LINCOLN PARK PLANNING COMMISSION
CITY HALL – COUNCIL CHAMBERS 1355 SOUTHFIELD ROAD
LINCOLN PARK, MICHIGAN

**Re: Auto Repair Facility Site Plan
970 Fort Street
City of Lincoln Park, MI
Hennessey Project 72111**

Regarding: Applicant for Site Plan Review and Special Land Use – 970 Fort St (Auto Sales and Service)

DATE:	07/08/2019
DRAWN BY:	MONIEER ALAHWAL
SCALE:	AS NOTED
* DO NOT SCALE DRAWING. Use figure dimensions only.	
SHEET TITLE: - EXISTING SITE PLAN / TOPO SURVEY (COVER SHEET)	
SHEET #: SP-1	
APPROVED BY:

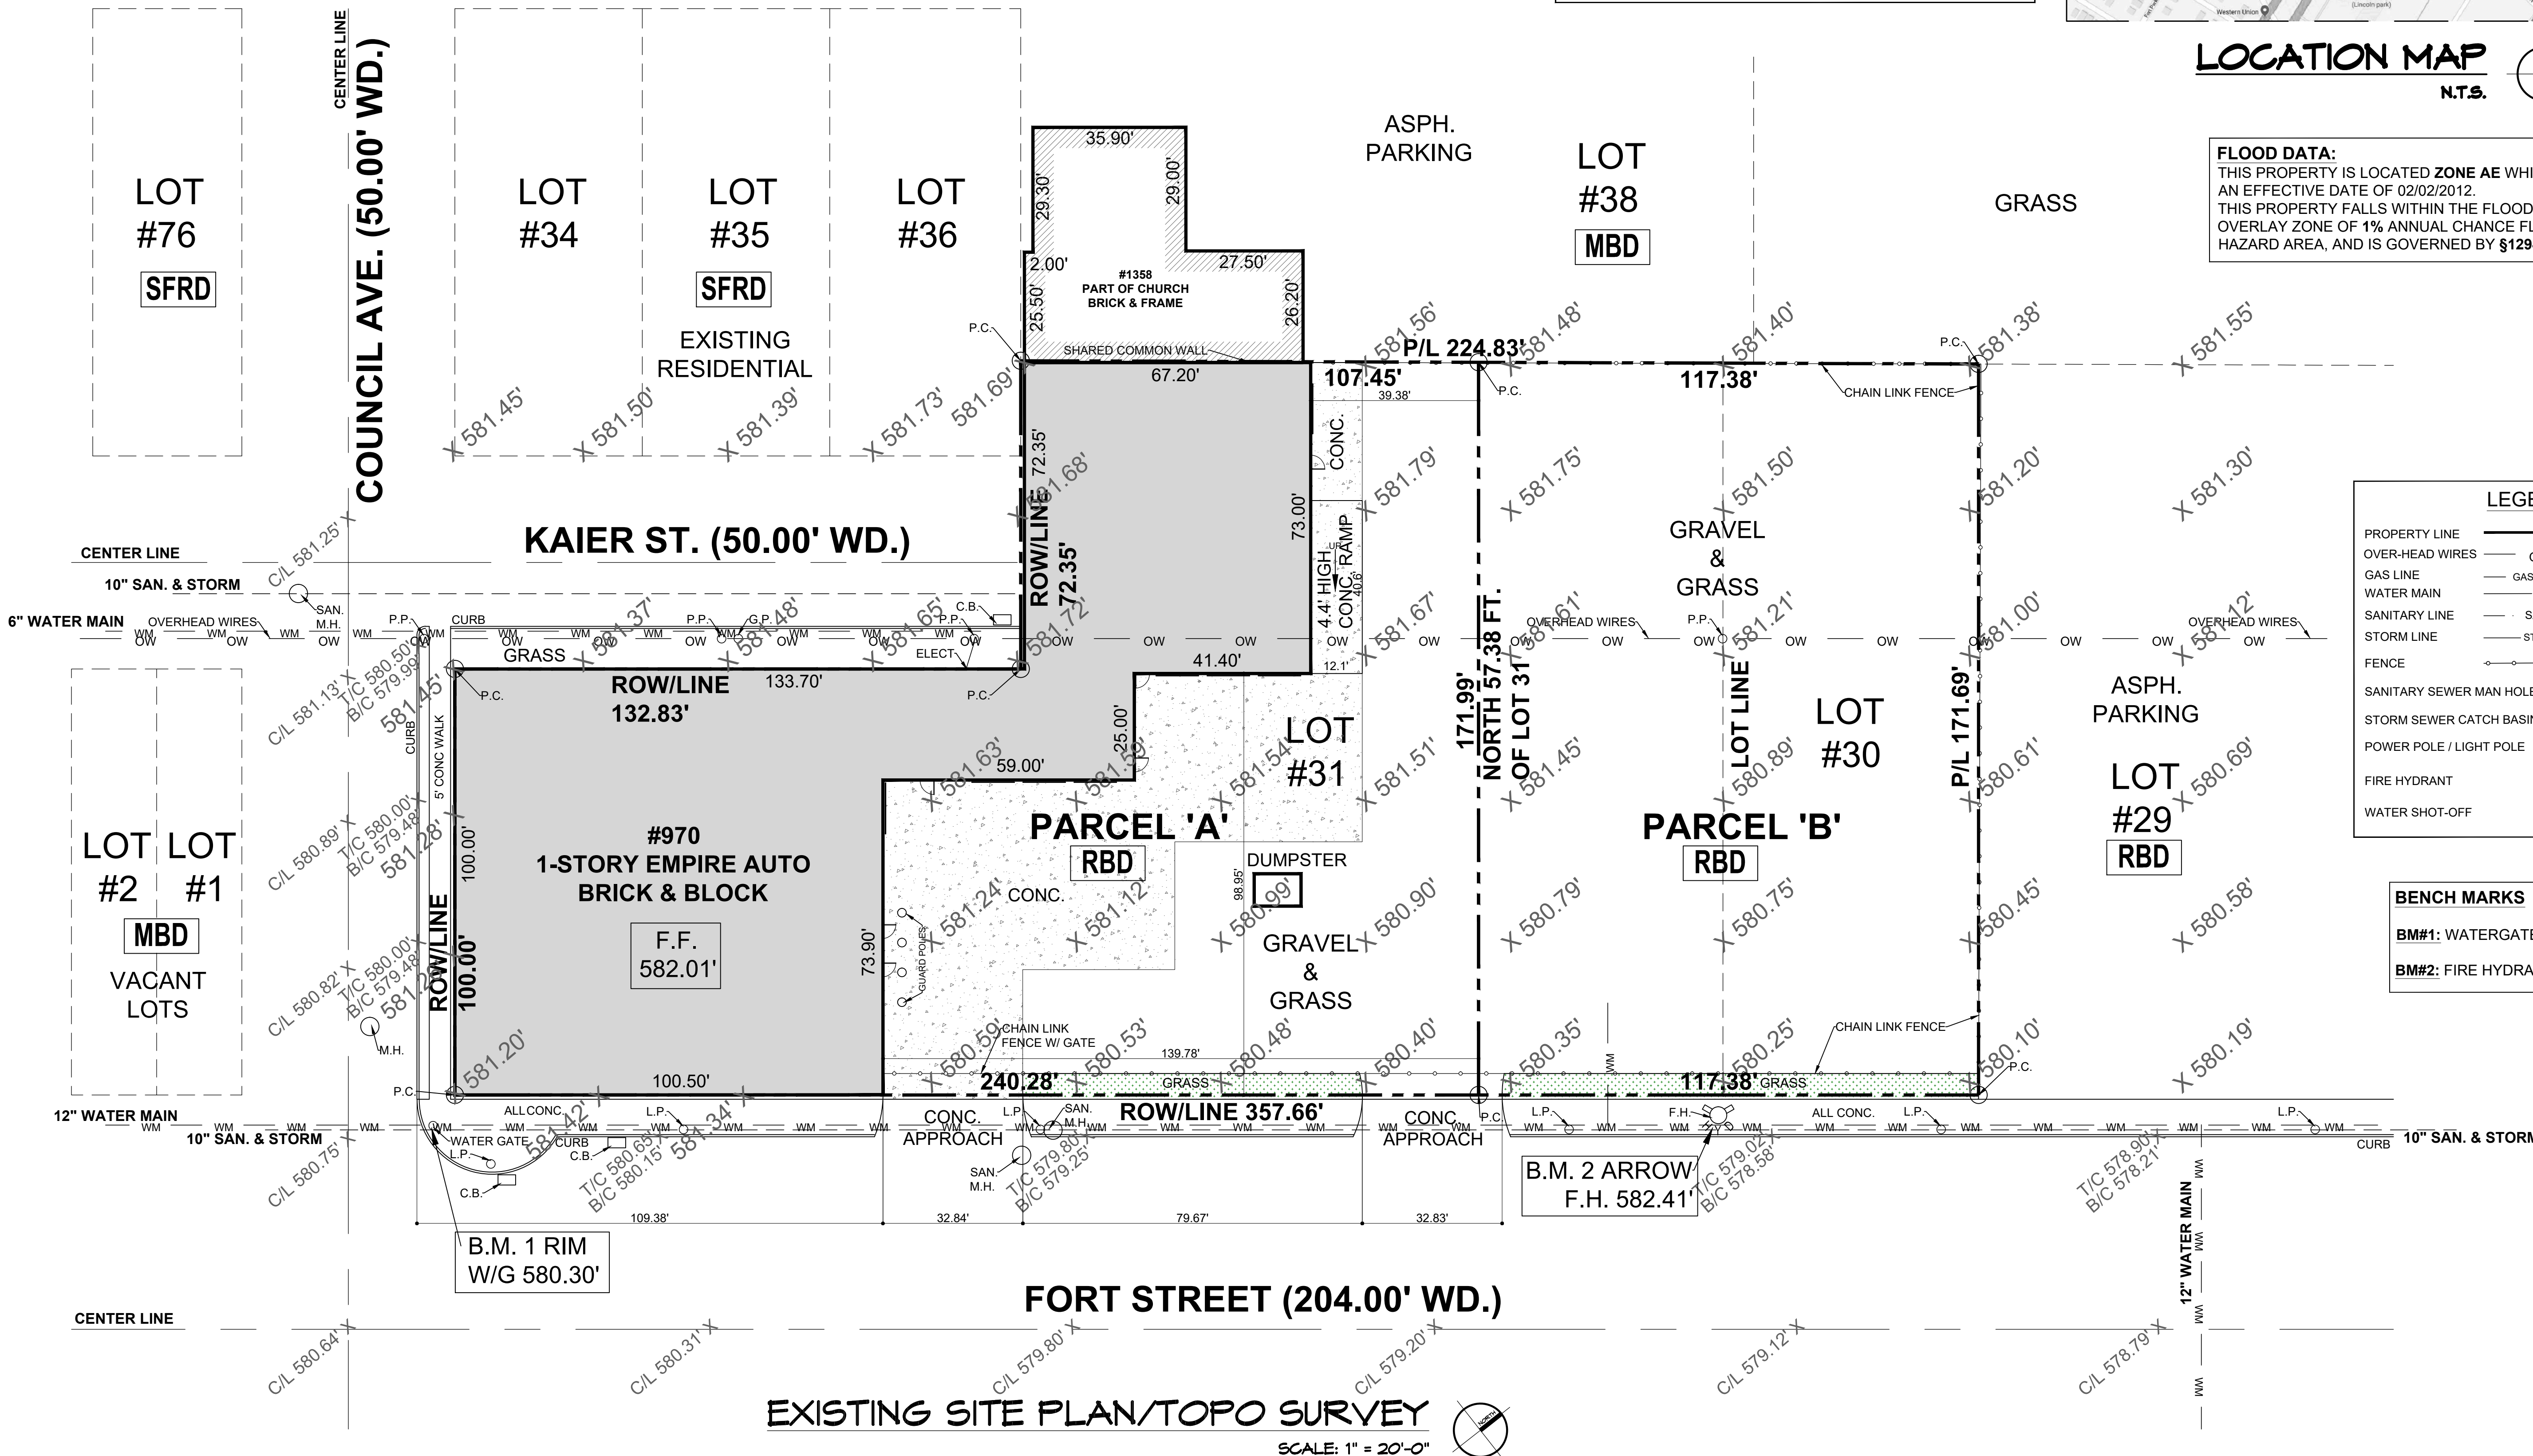
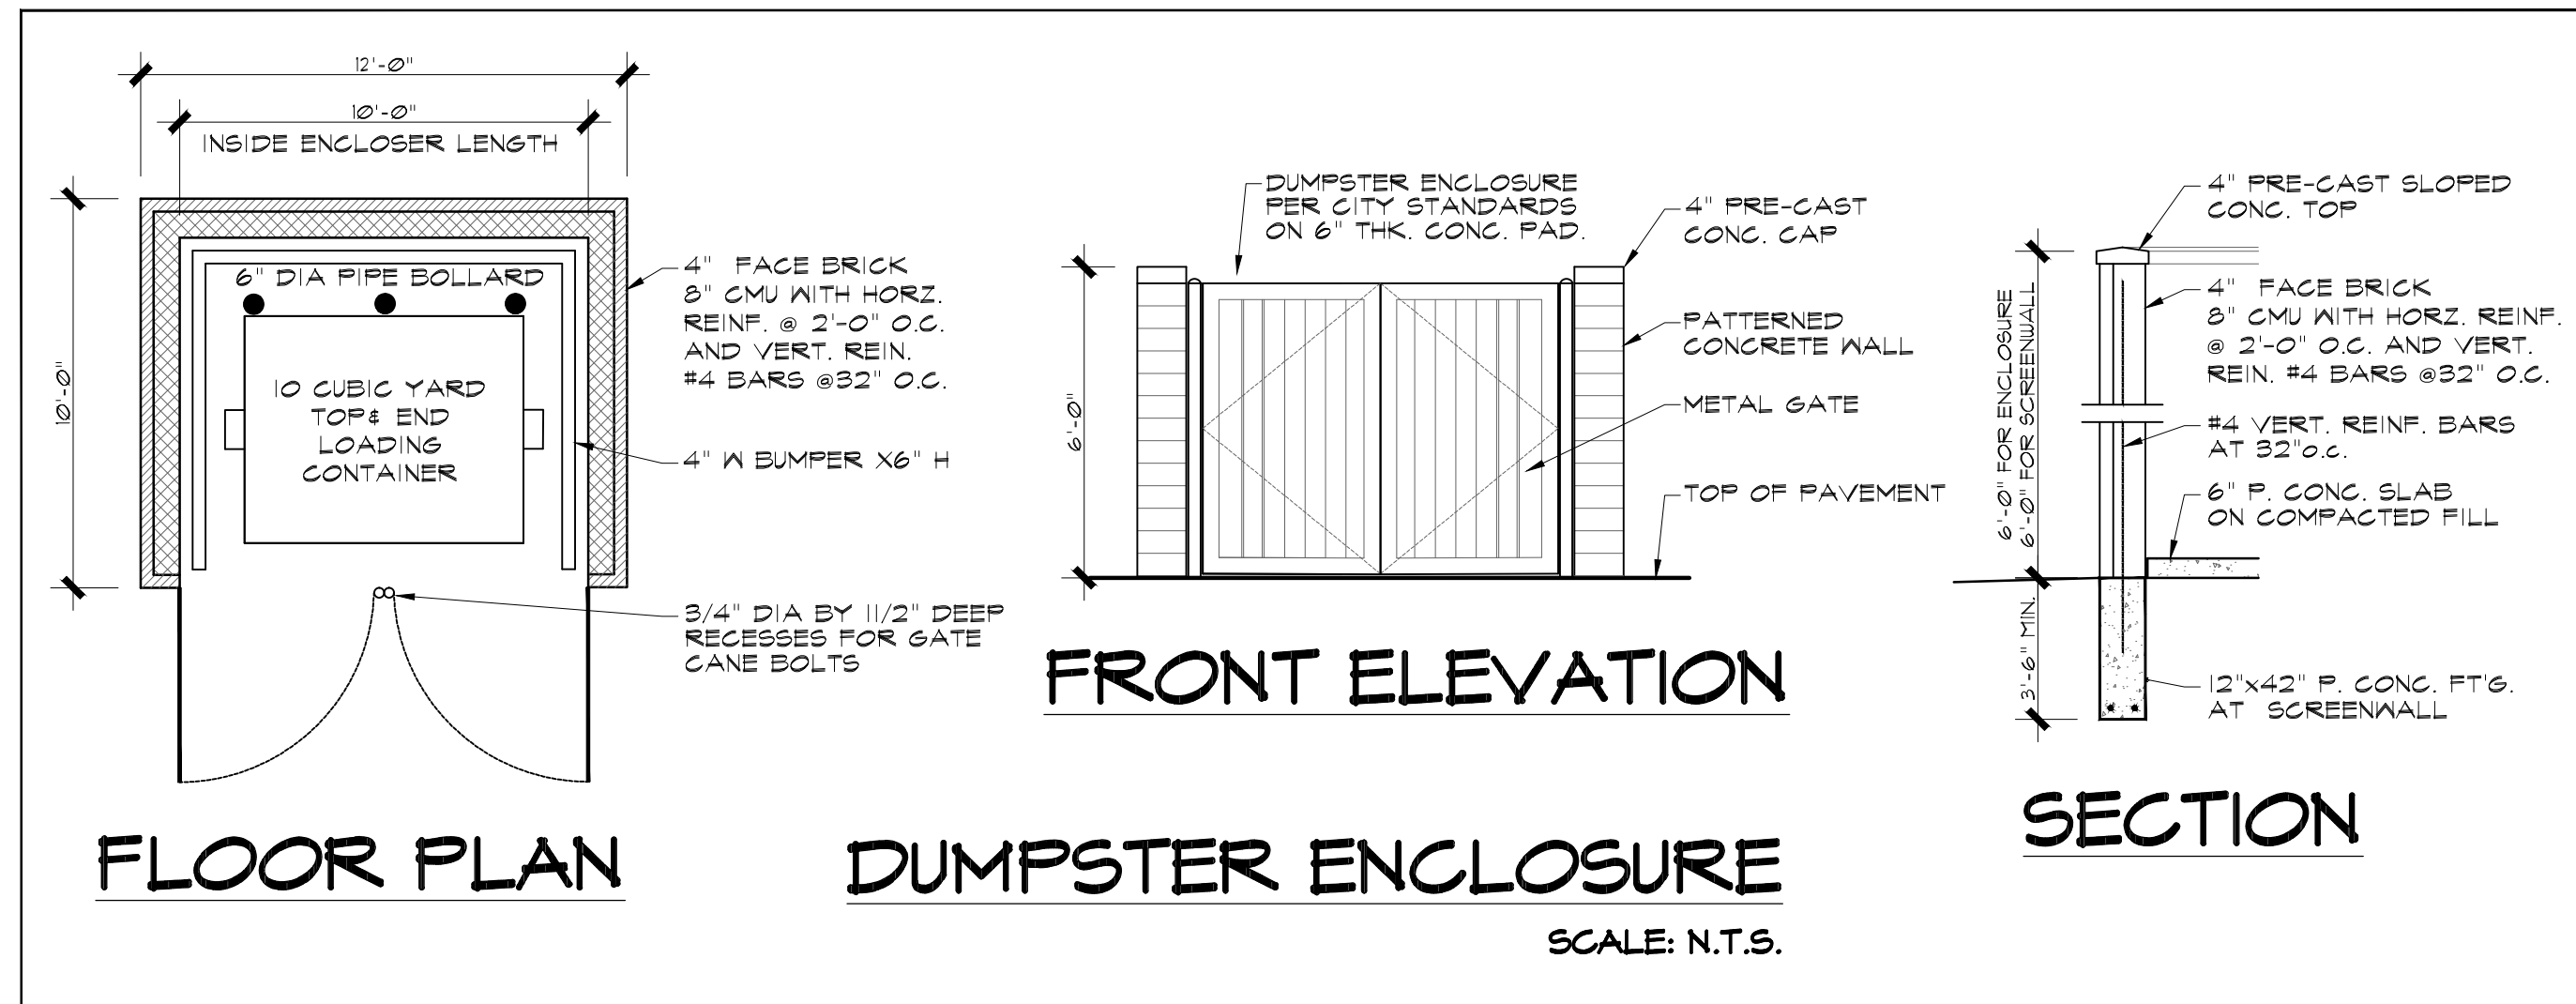
1. The plans acknowledge the site is in a flood plain. They do not indicate part of the site is in a floodway. The flood plain and floodway should be clearly indicated on the site plan.
2. Work within the flood plain may require an EGLE/CORP joint Permit. Any work in the floodway will require an EGLE/CORP joint Permit.
3. It appears that the building is located in the flood plain. The engineer must verify that the finish floor is above the flood plain elevation. If possible a LOMA or LOMR may need to be filed.

- Applicant shall clearly indicate the floodplain and floodway on the Existing and Proposed Site Plan; Sheets SP-1 SP-2.*
- Applicant shall apply for a floodplain boundary to determine the parts of the site that falls within the regulatory floodway and the parts that falls within 1% annual chance flood hazard.*
- Applicant shall verify that the finish floor is above the floodplain elevation. If possible, a LOMA or LOMR may need to be filed.*
- Applicant shall work with Michigan Department of Environmental Quality (MDEQ) to ensure the building conforms with its regulation and get all the required permits.*

SHEET #: SP-2

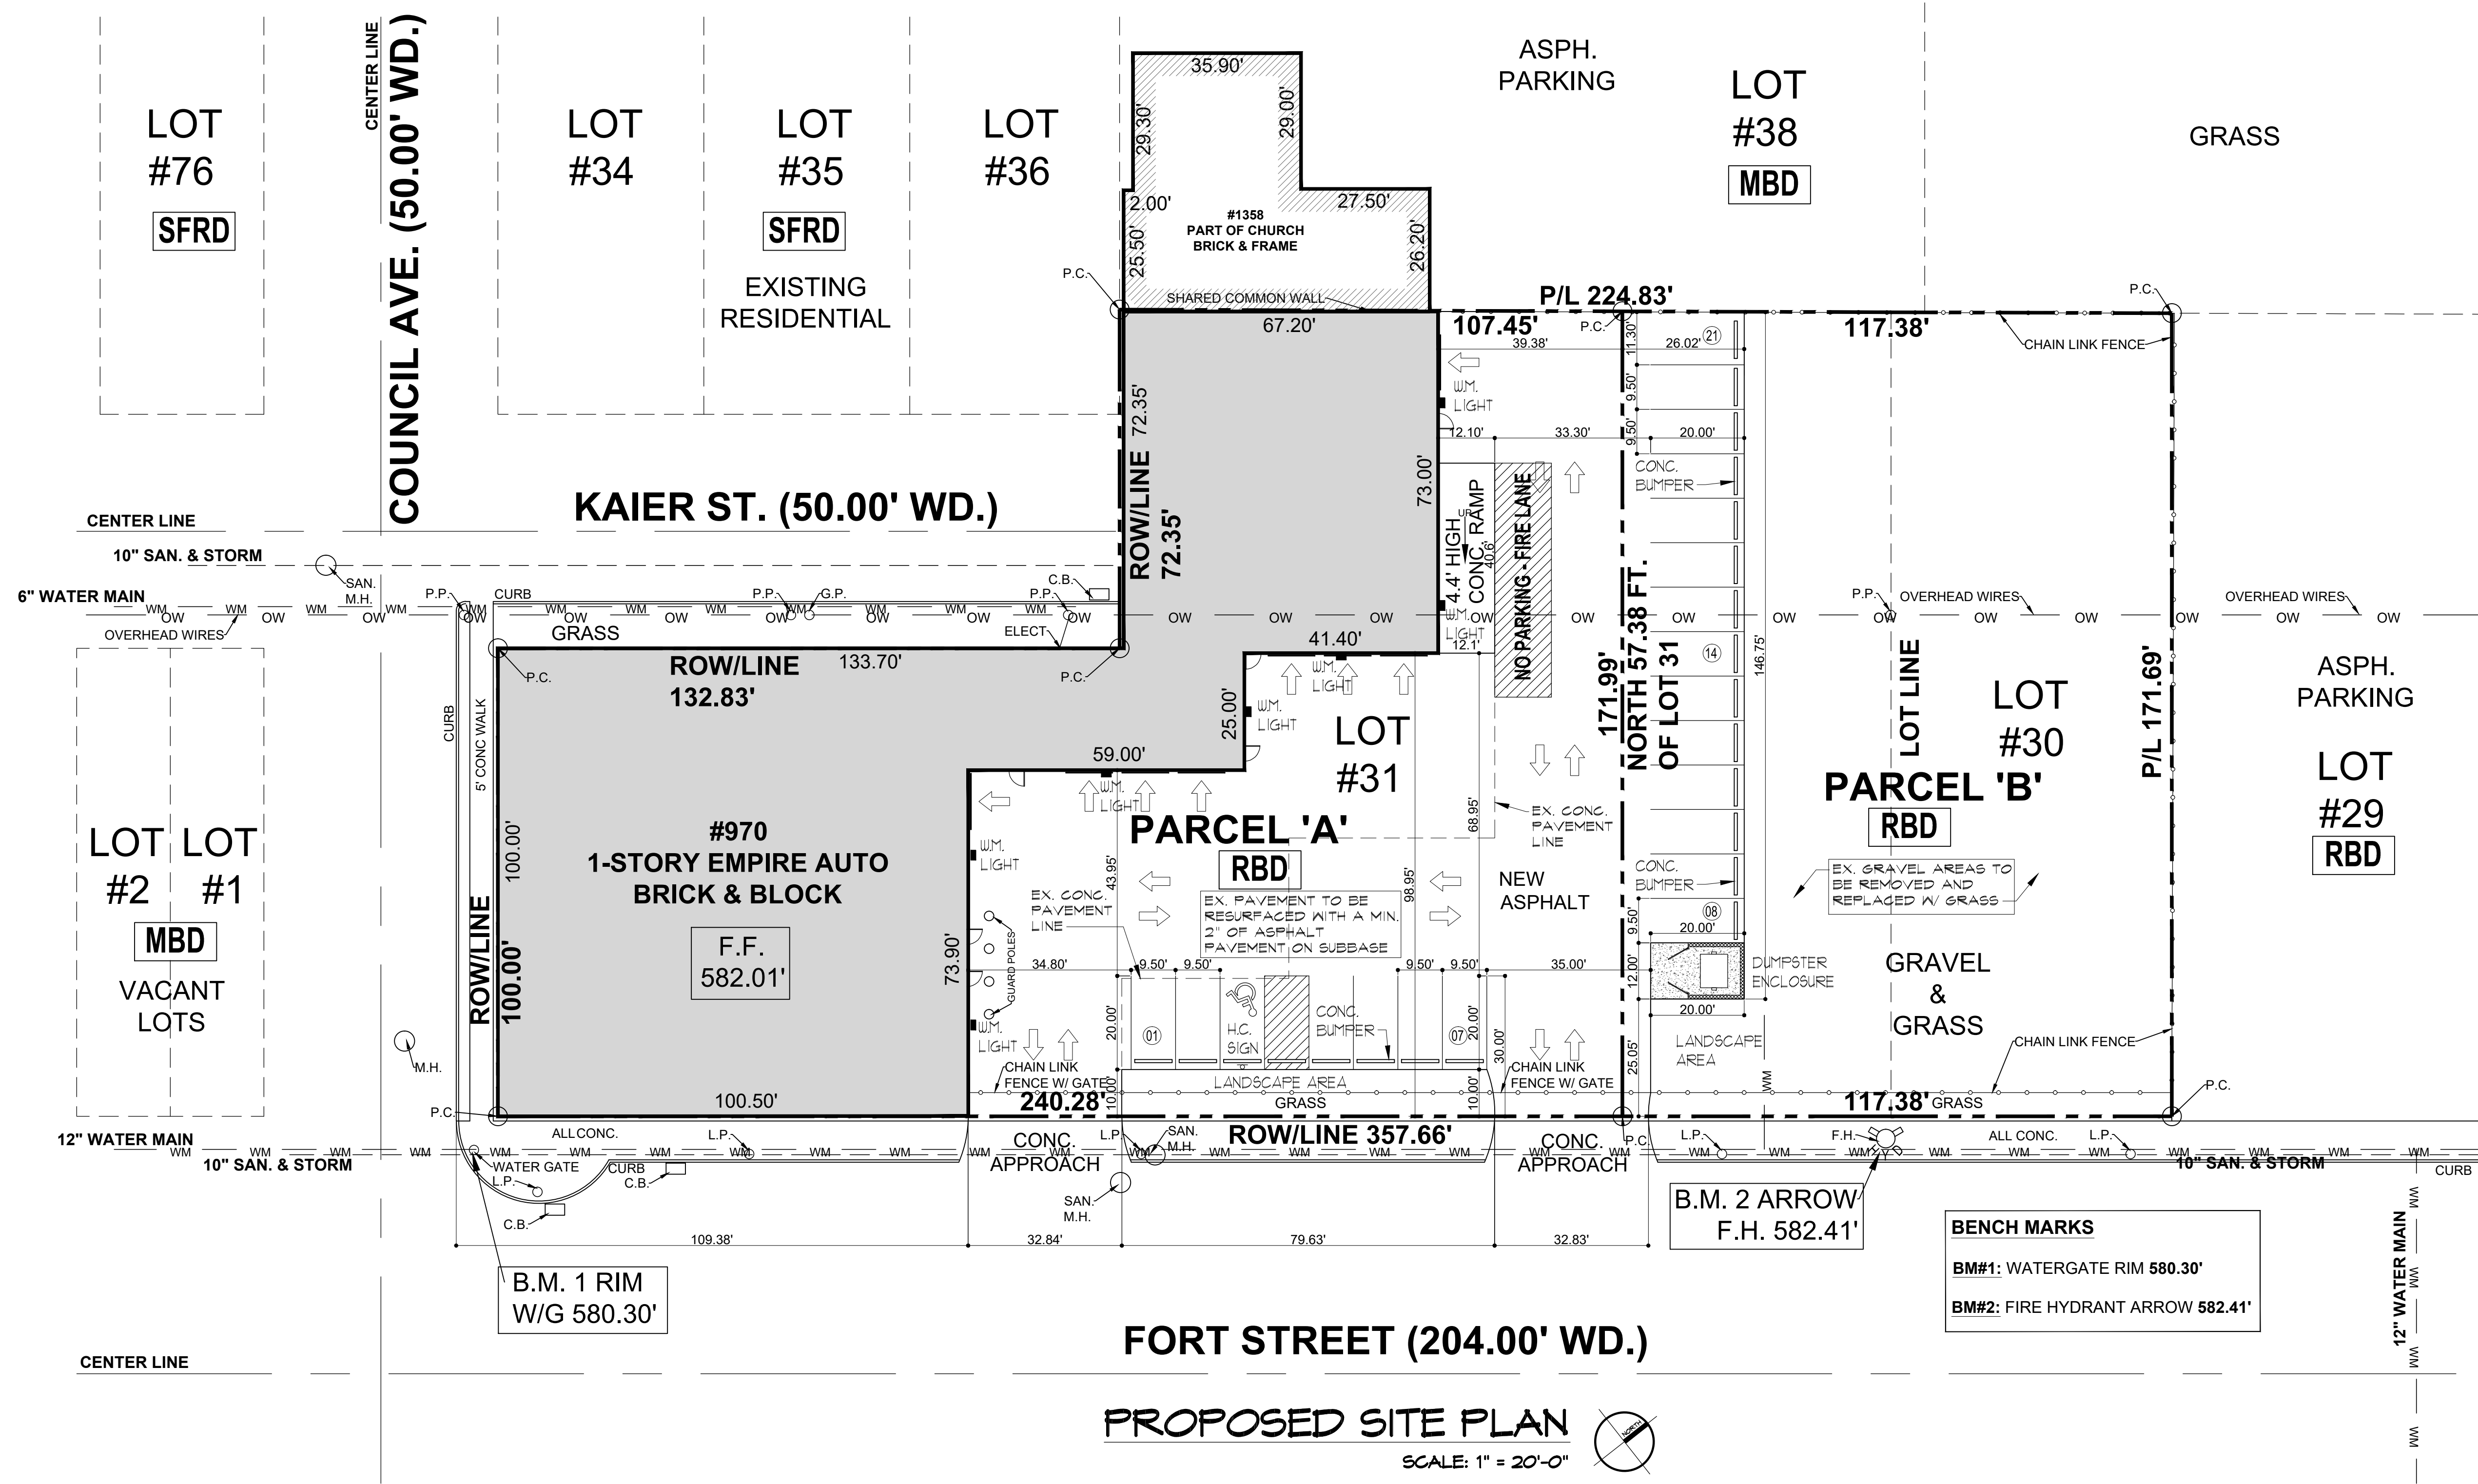
1. The southerly drive approach is broken and will need to be replaced.
2. The proposed work in the parking lot will need to be evaluated during the detailed engineering site plan review

- Driveways and curb cuts are larger than permitted by either 1290.10 or 1294.14*
- Curb cuts exceed the maximum number permitted*
- Applicant shall provide concrete raised curb (6) Inches along the landscaped areas.*

- Planning Commission waiver sought to reduce the number of required parking spaces from 25 to 21 (provides 84% of requirement)*
- Applicant shall provide indicate and detail curb and gutter.*
- Applicant shall ensure that the broken south drive approach must brought up to the City Standards.*
- Proposed work in parking lot will be evaluated for adequacy during detailed engineering review*
